ATTACHMENT 4 TO AEP:NRG:1182

CONTROL ROD
MISALIGNMENT ANALYSIS

DONALD C. COOK NUCLEAR PLANT
CONTROL ROD MISALIGNMENT ANALYSIS

AMERICAN ELECTRIC POWER SERVICE CORPORATION

Figure 3.1-1

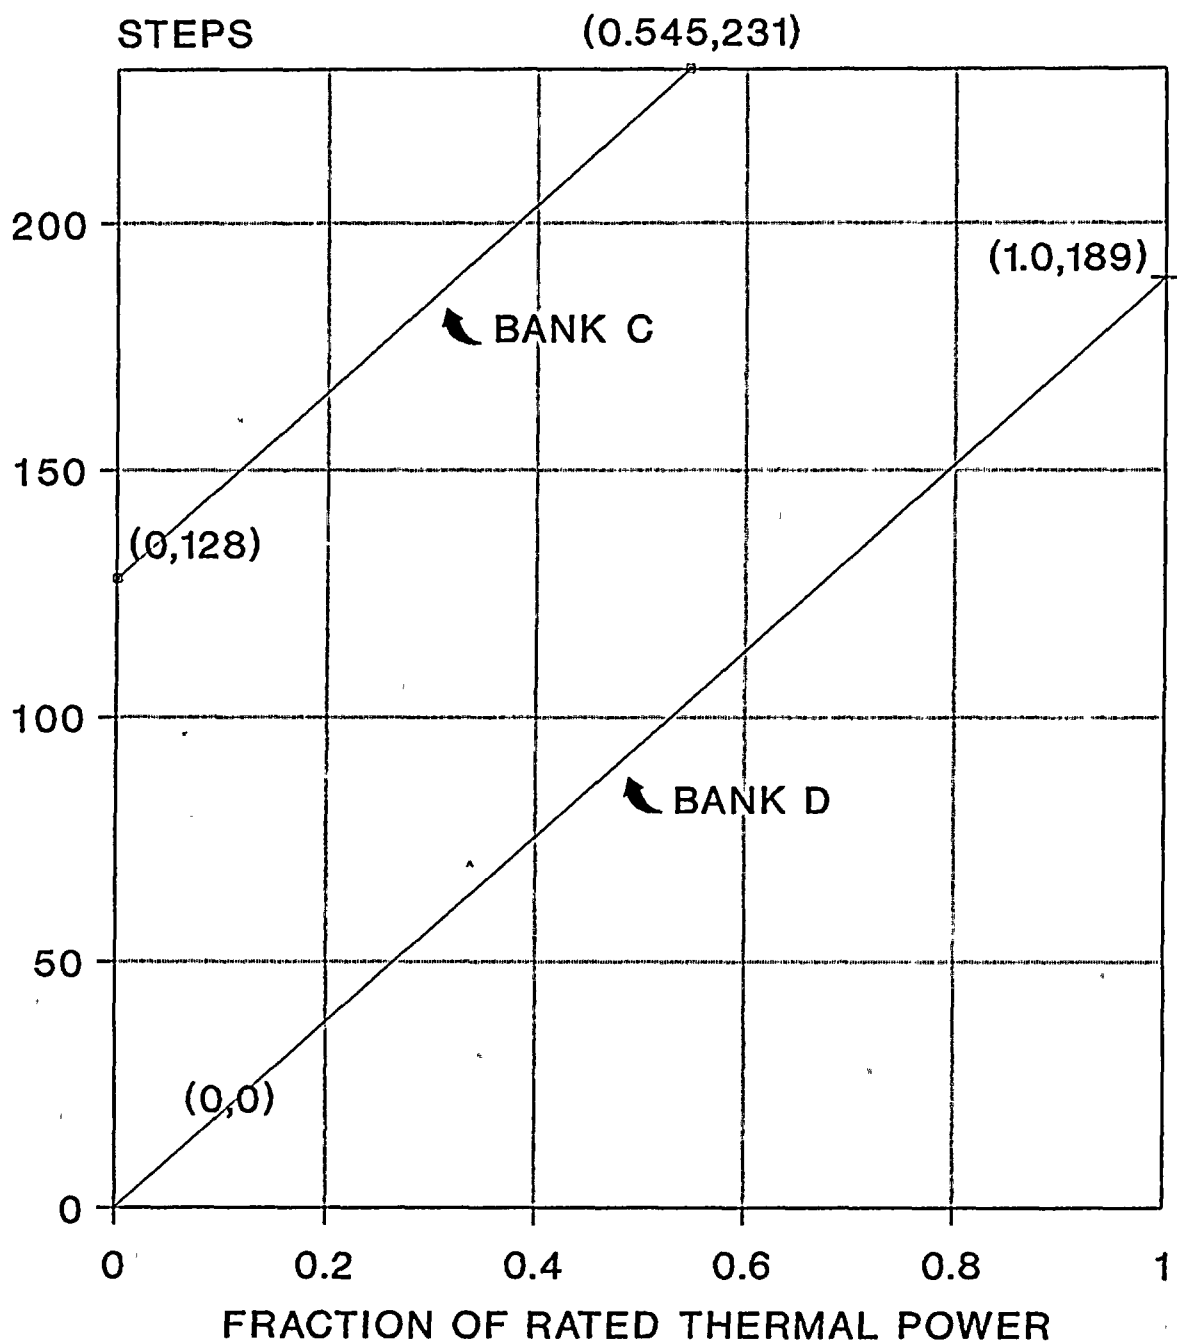
Since a new rod insertion limit was used in the analysis, the unit 1 PDIL will be changed to reflect the limit used in the analysis at the beginning of cycle 14.

FIGURE 3.1-4

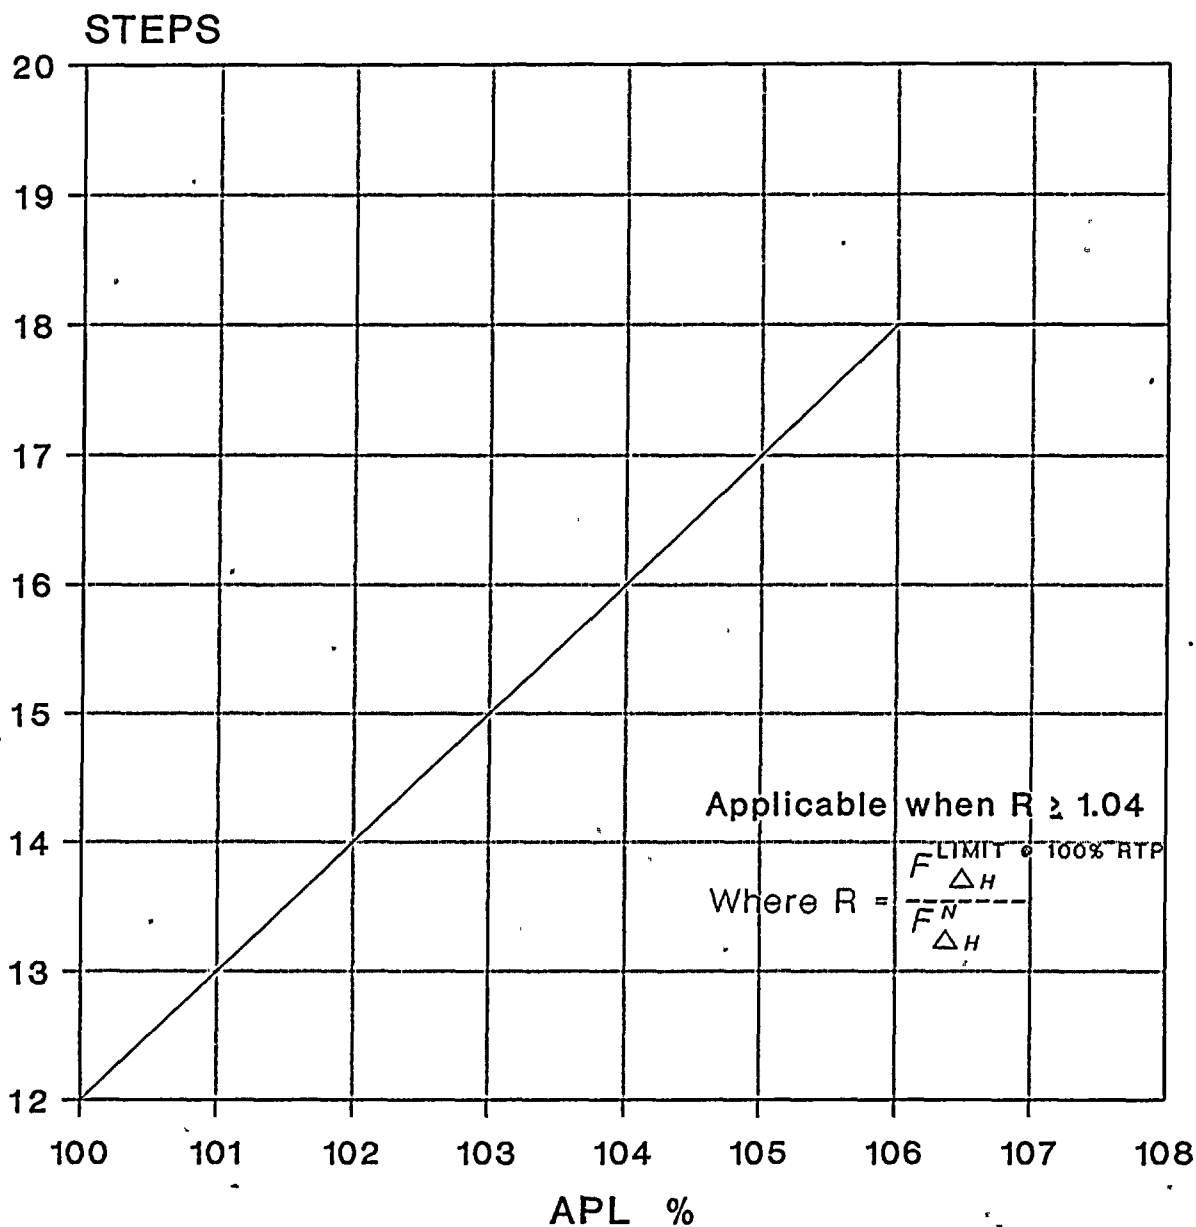
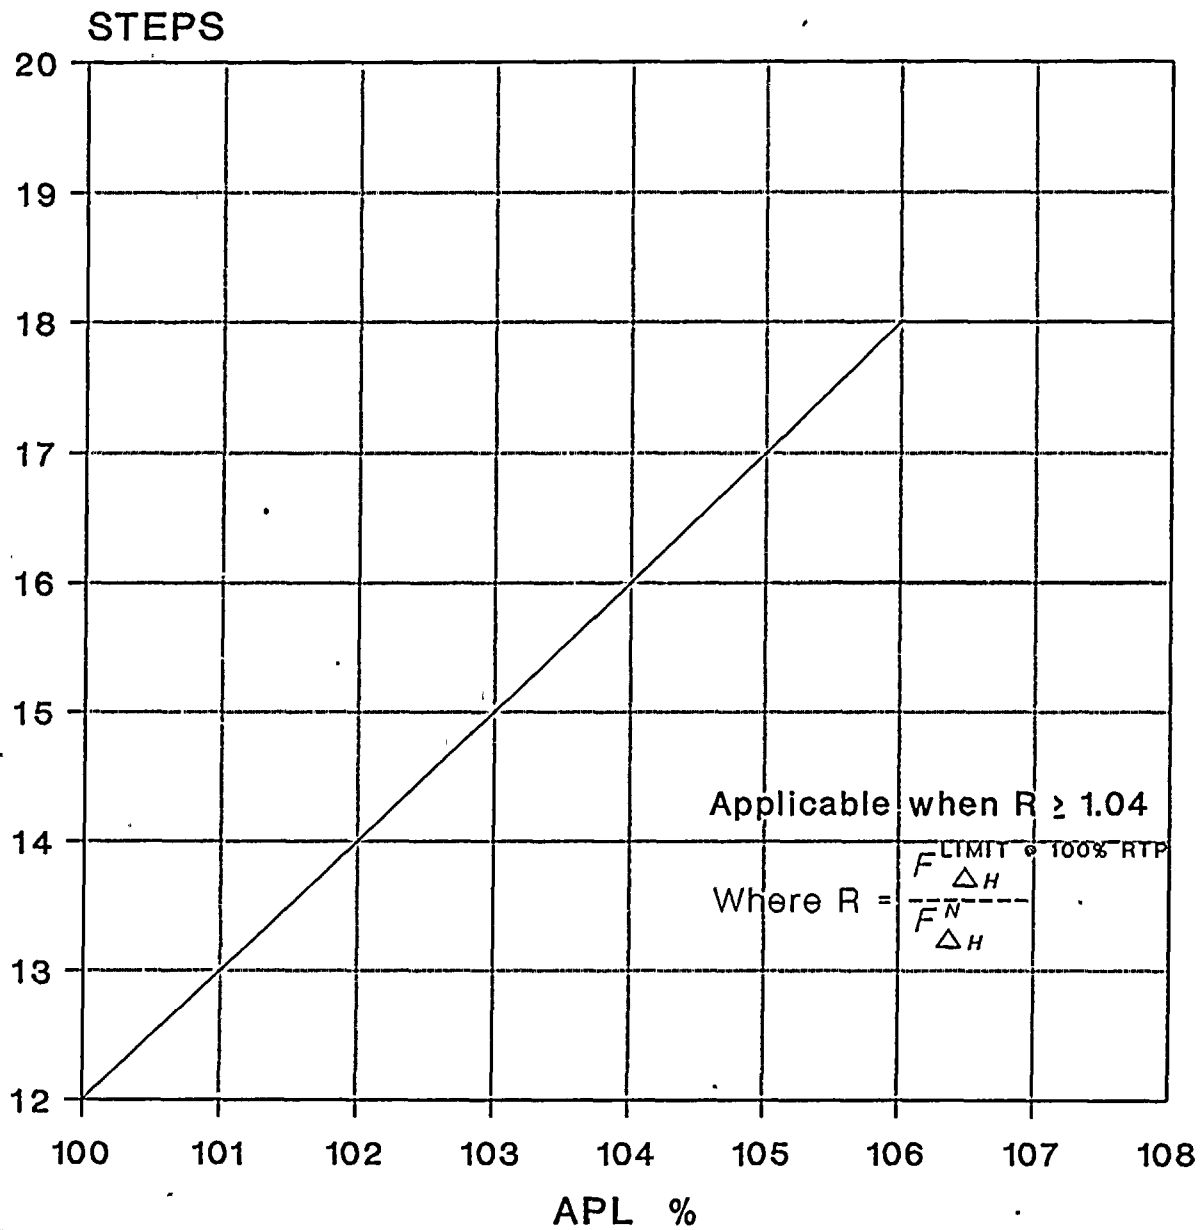
The current T/S basis references a 4% $F_{\Delta H}$ margin for uncertainties arising from abnormal perturbations in radial power shape. This analysis shows that a 0.8% margin in $F_{\Delta H}$ is required to take into account an 18-step (indicated) misalignment. Therefore, the conservative requirement of 4% margin is retained and is adhered to in a strict manner by specifying this requirement in T/S figure 3.1-4 (Appendix B).

Therefore, if the APL given in the monthly incore flux map is 106% and if the value of R (margin in $F_{\Delta H}$) is 1.04, then an additional six-step misalignment is allowed above 85% RTP. If the APL is lower, then a lower amount of misalignment is allowed. This is graphically shown in T/S

As seen in Section 5.1, the updated T/Ss allow a rod misalignment of ± 18 steps for power levels less than or equal to 85% RTP. Above 85% RTP, the level of misalignment allowed is based on the peaking factors obtained from the monthly incore flux map taken. For this, the plant procedure, "Surveillance of core power distribution limit," (**1EHP 4030 STP.330 and **2EHP 4030 STP.330) will be revised to provide the allowed rod misalignment on a monthly basis. The incore flux map gives the values for APL and $F_{\Delta H}$ and from T/S Figure 3.1-4, the additional rod misalignment is obtained.

Since the value of R obtained is greater than 1.04, from T/S Figure 3.1-4, for an APL of 103%, a misalignment of 15 steps is obtained for power levels greater than 85% RTP. In order to assist the reactor operator in determining the allowed rod misalignment, a plot as shown below may be provided.

- o for THERMAL POWER less than or equal to 85% of RATED THERMAL POWER, the allowed rod misalignment is ± 18 steps, and
- o for THERMAL POWER greater than 85% of RATED THERMAL POWER, the allowed rod misalignment is ± 12 steps or as determined from Figure 3.1-4. Figure 3.1-4 permits for an allowed rod misalignment from ± 13 steps (for APL equal to 101%) to ± 18 steps (for APL greater or equal to 106%) provided the value of R (defined in Figure 3.1-4) is greater than or equal to 1.04.

4.1.3.1.3 The allowed rod misalignment for THERMAL POWER greater than 85% of RATED THERMAL POWER shall be determined in conjunction with the measurement of APL as defined in Specification 4.2.6.2.
